GSGNY Bid Addendum Two (2)

Date: 8 July 2022

Project Name: Girl Scouts of Greater New York (GSGNY)

Project Number: 2005

Drawing Title
FIRST FLOOR
CONSTRUCTION PLAN

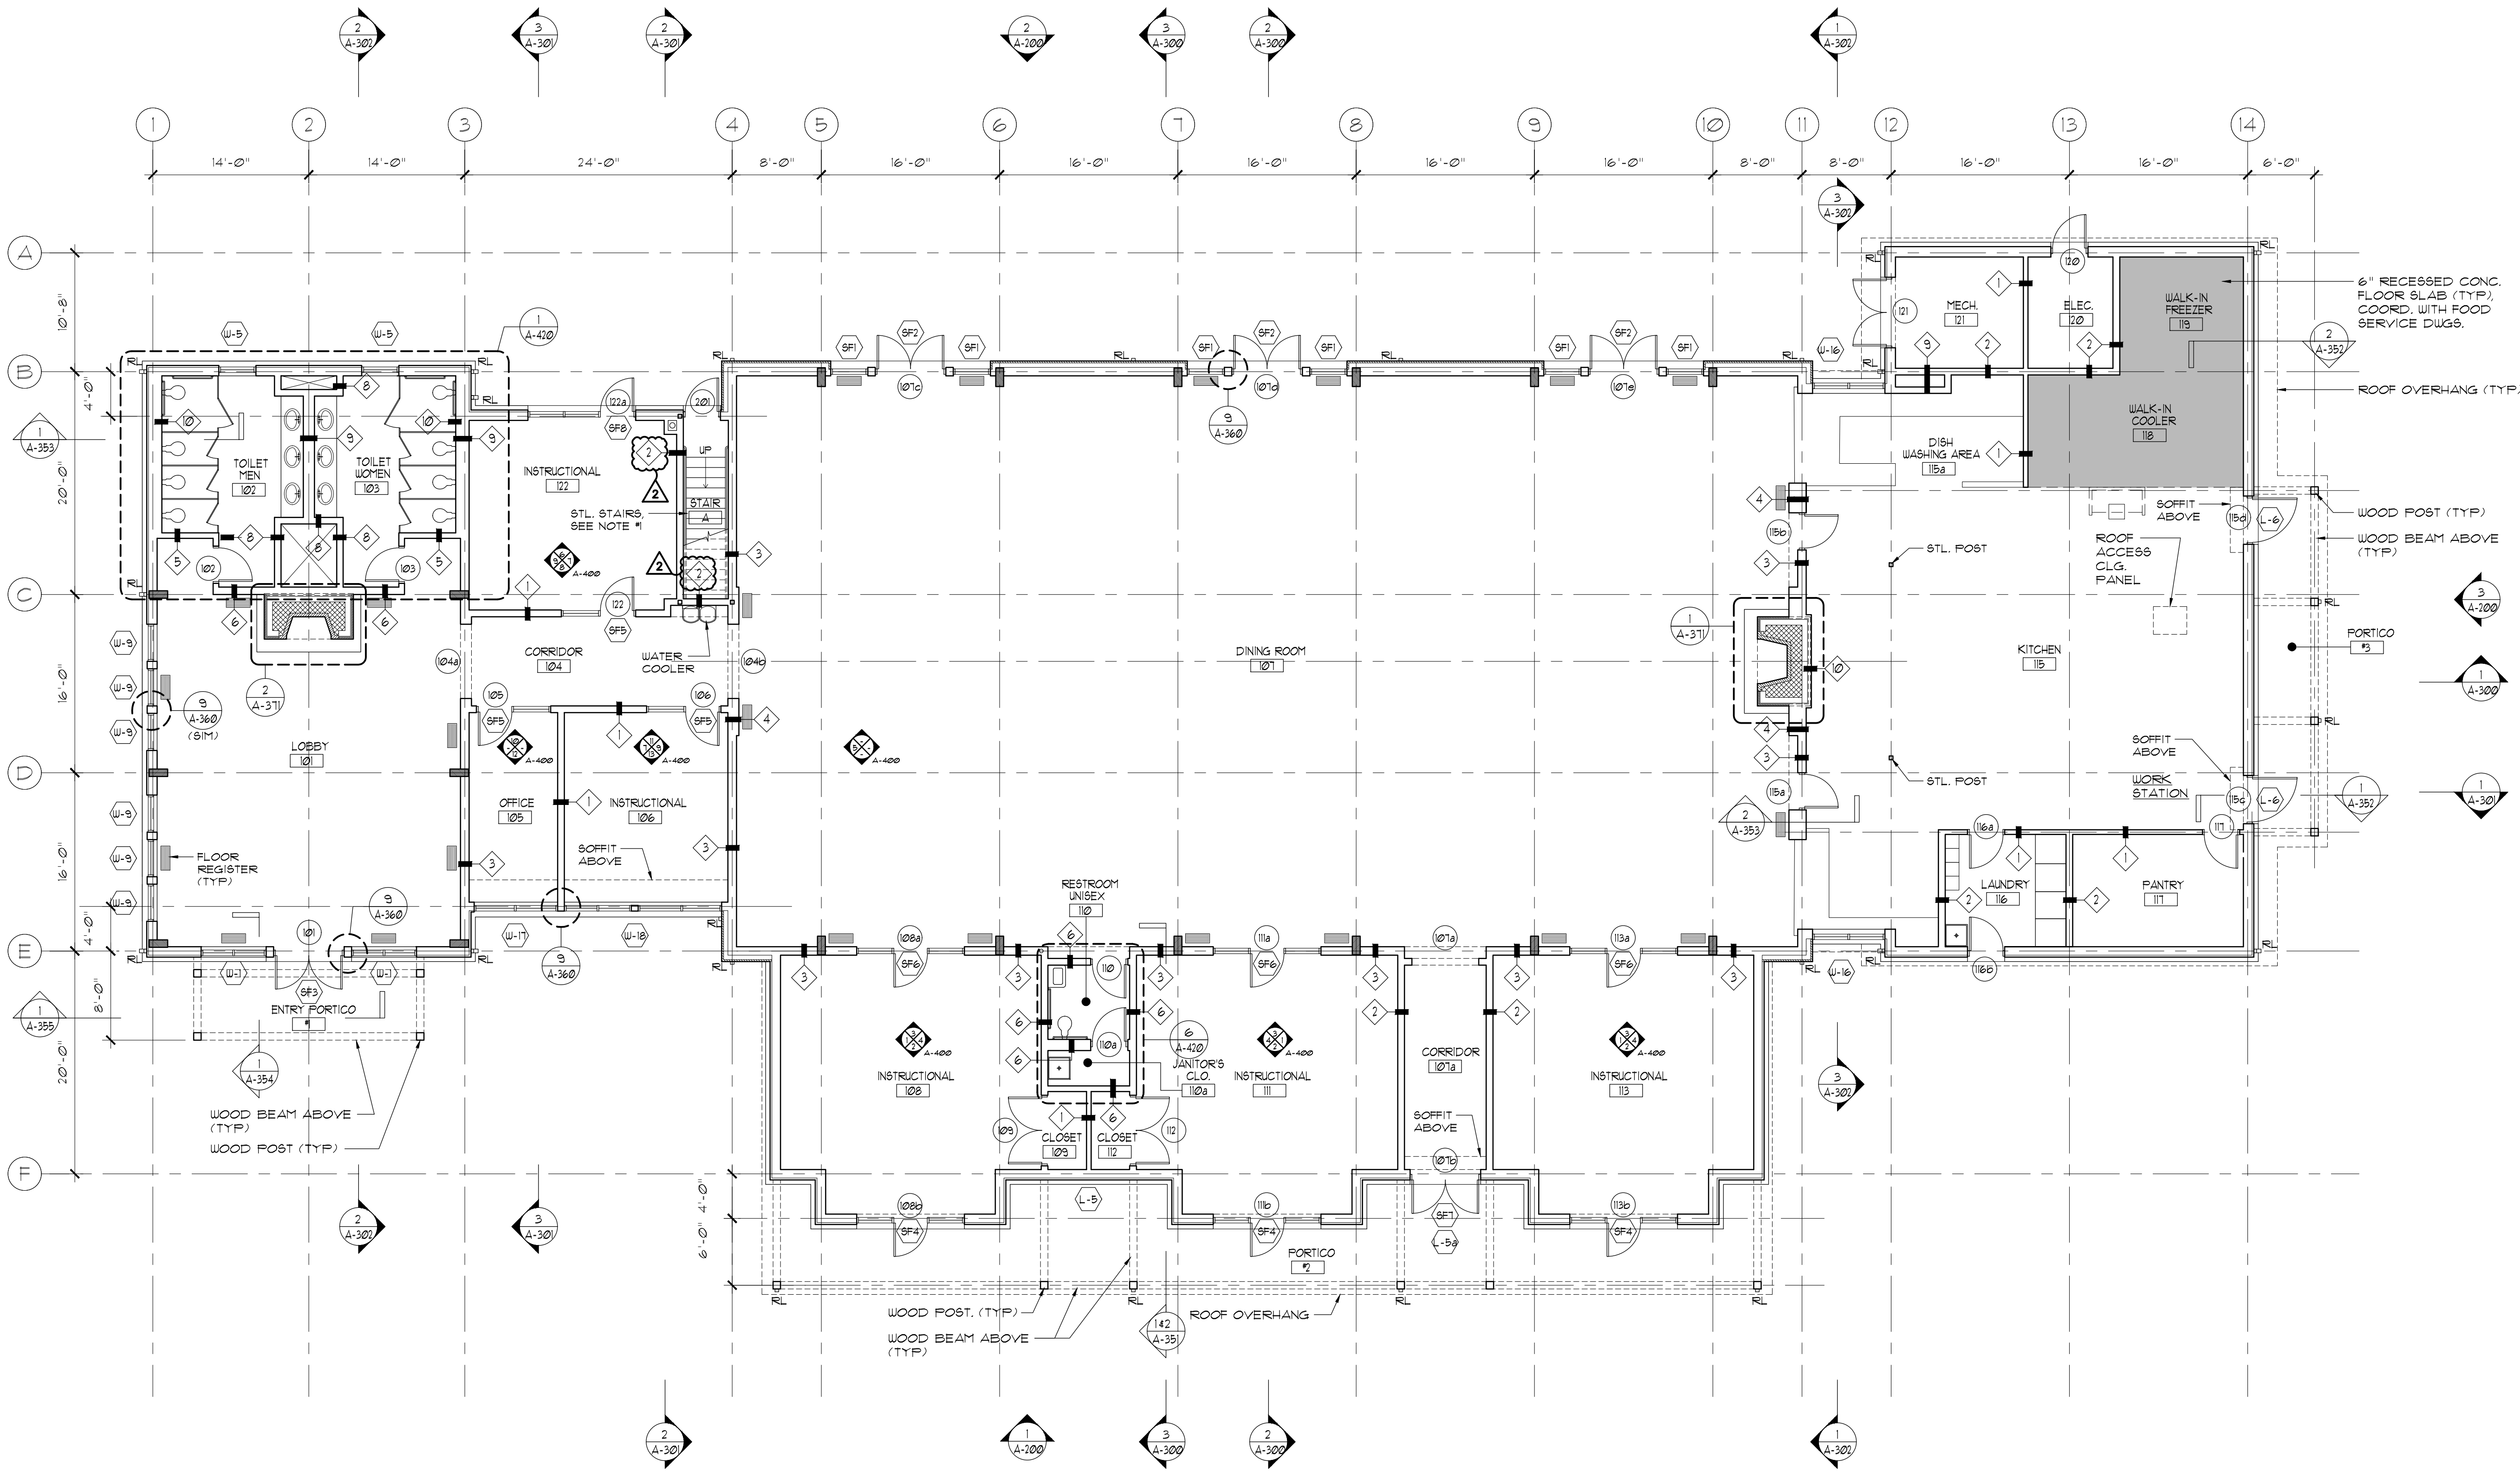
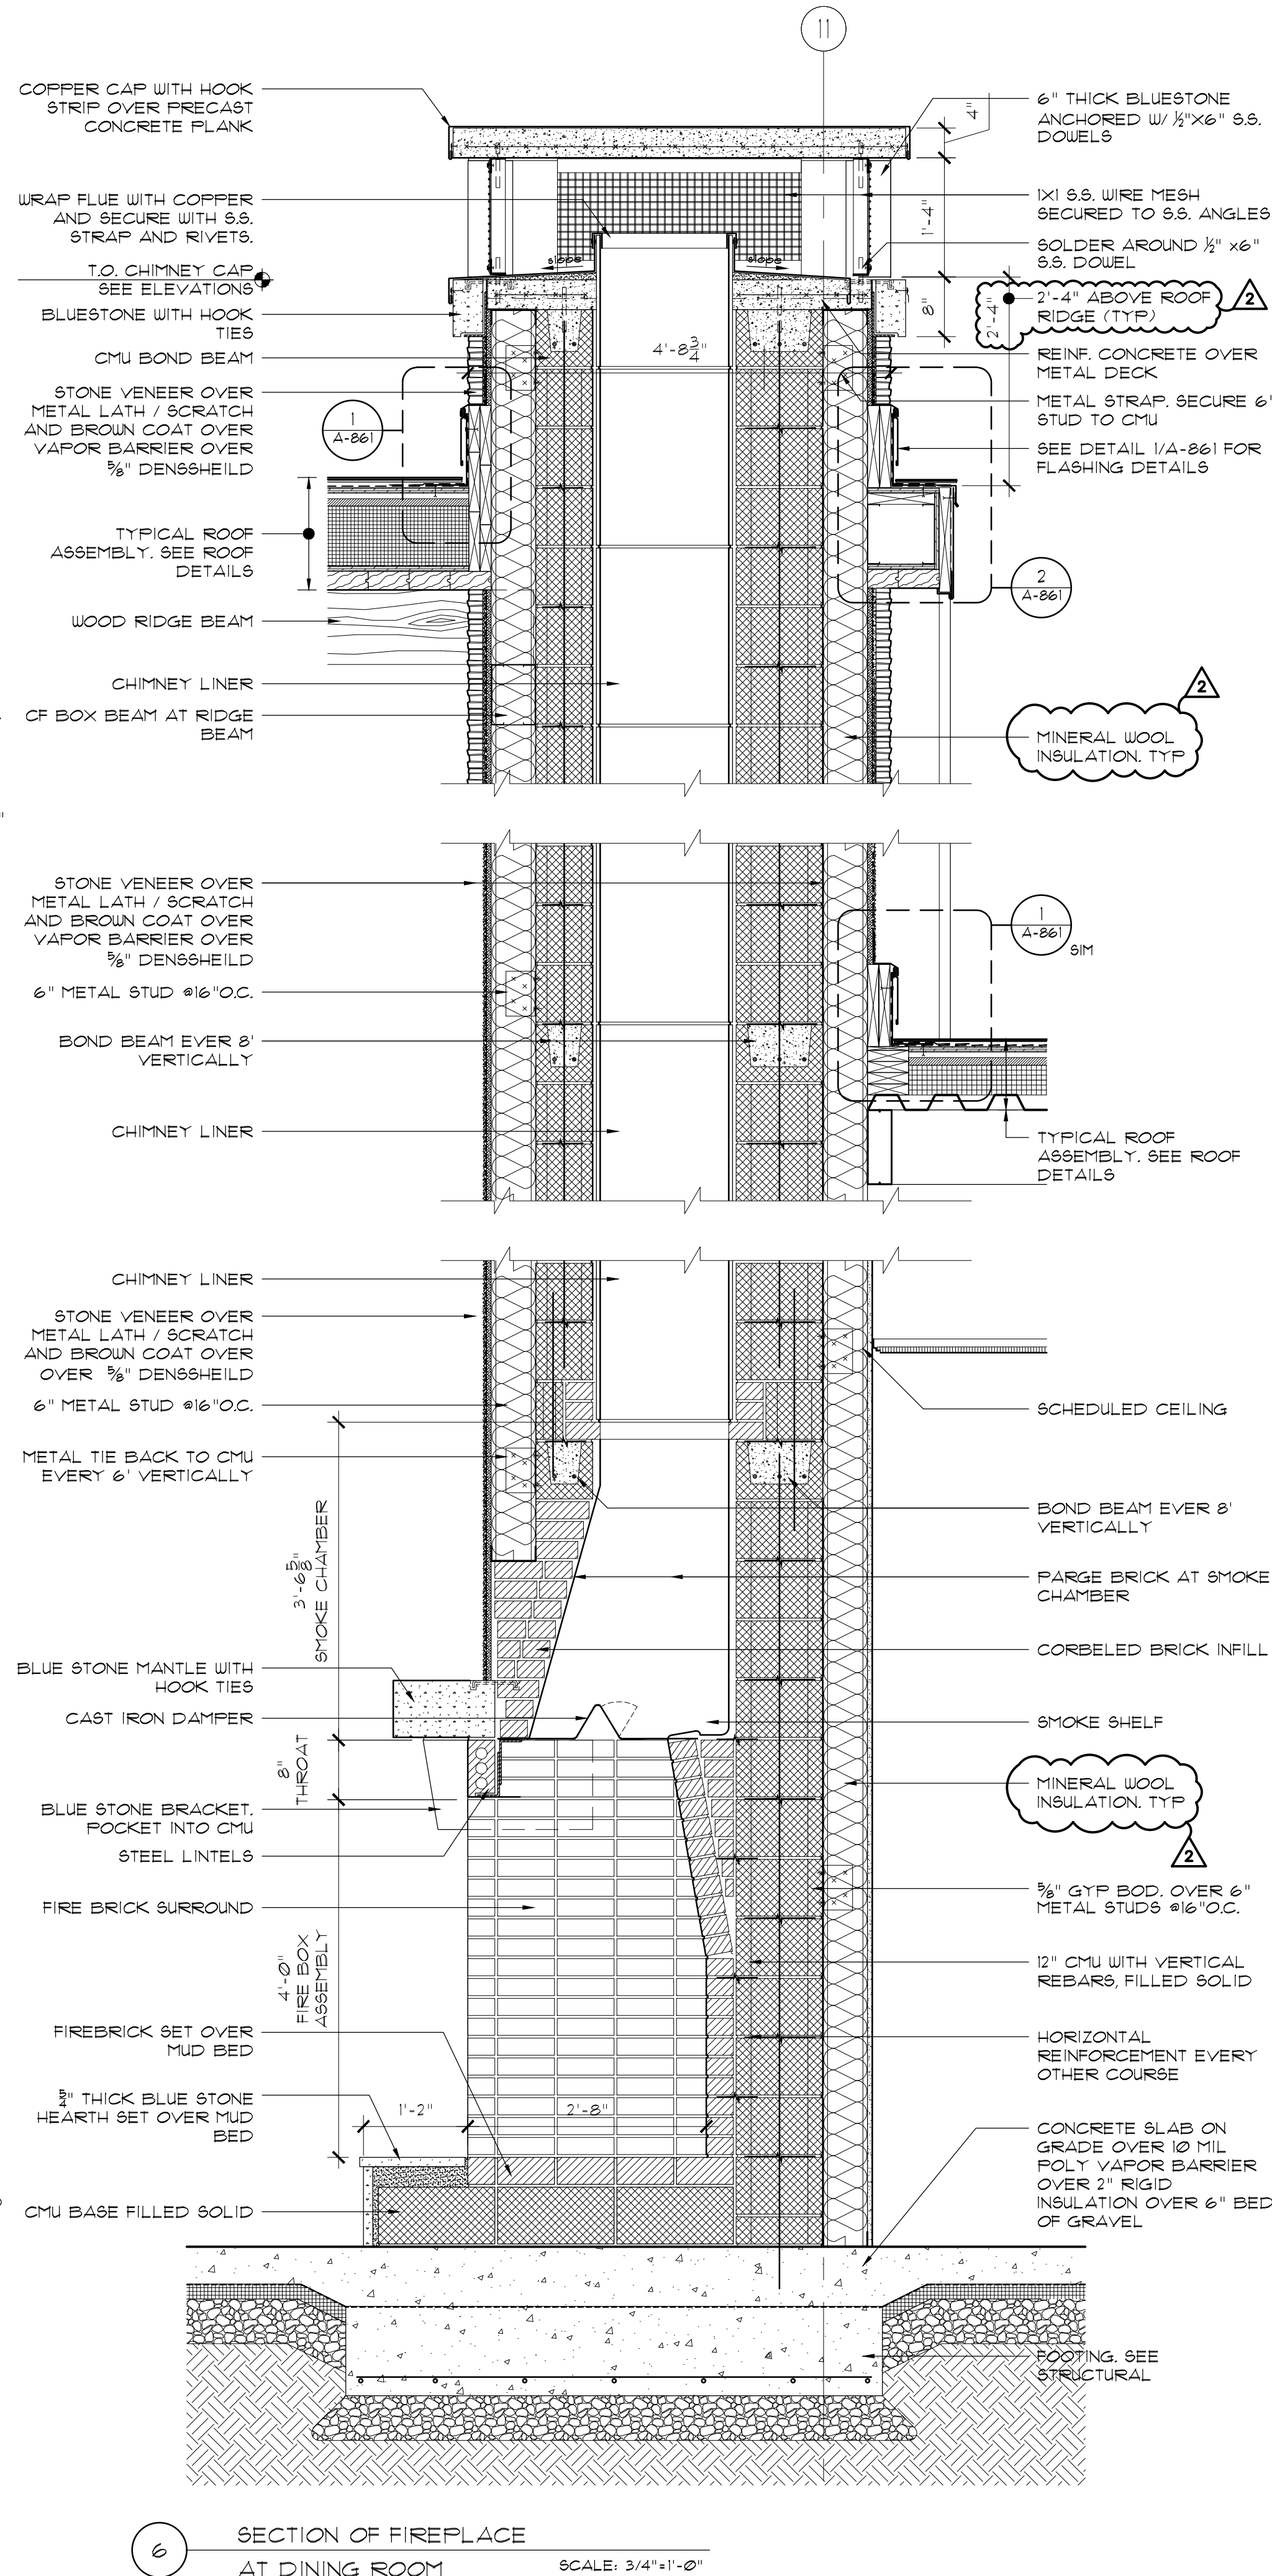
- A-101 First Floor Construction Plan
 - Wall type clarification at stair – wall type 2
- A-360 Enlarged Details
 - Clarification of precast post base size
 - Clarification of precast sills at exterior doors
- A-371 Fireplace Details
 - Clarification that insulation at fireplace is to be mineral wool type
 - Clarification of chimney height
- A-900 Door Schedule
 - Revision to door type D2 to HM with vision lite
 - Clarification of aluminum storefront door type (see below for spec clarification)
 - Clarification to Door SF3 as thicker 2.25: Insulpour door (see below for spec clarification)
- A-901 Window Schedule
 - Added L-7 louver on north side
 - Clarification to glazing key (see below for spec clarification)
